Comment Resolution for the MR-O-QPSK PHY

Title: Proposed Comment Resolution of the MR-O-QPSK PHY
Date Submitted: July 14, 2010
Source: Michael Schmidt - Atmel (email: michael.schmidt@atmel.com)
Re: Task Group 15.4g LB51 comment resolution
Abstract: Comment resolutions for the MR-O-QPSK PHY
Notice: This document has been prepared to assist the IEEE P802.15. It is offered as a basis for discussion and is not binding on the contributing individual(s) or organization(s). The material in this document is subject to change in form and content after further study. The contributor(s) reserve(s) the right to add, amend or withdraw material contained herein.
Release: The contributor acknowledges and accepts that this contribution becomes the property of IEEE and may be made publicly available by P802.15.

CID 1470

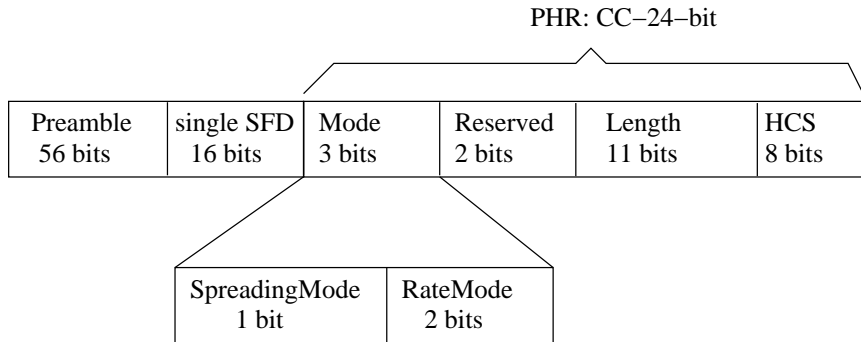
- ▶ Comment:
 - ▶ During PHR reduce spreading gain but introduce FEC.
- ▶ Response:
 - ▶ Accept.
- ▶ Resolution:
 - ▶ FEC based on terminated and interleaved convolutional coding
 - ▶ Option B
 - ▶ pilots to simplify traceback
 - ▶ For details see doc # 435
